Service Bulletin

Bulletin No.: PI1262

Subject: Noise Heard from Center Console

Models: 2014 Chevrolet Silverado 1500
2014 GMC Sierra 1500

3925866

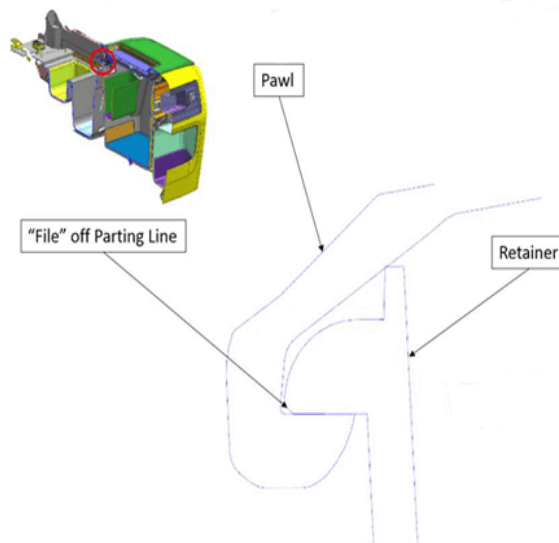
Some customers may comment on a noise heard from the center console.
This condition may be caused by a plastic burr on the center console retainer.

Modify the retainer using a file to remove the parting line as shown in the illustration above.
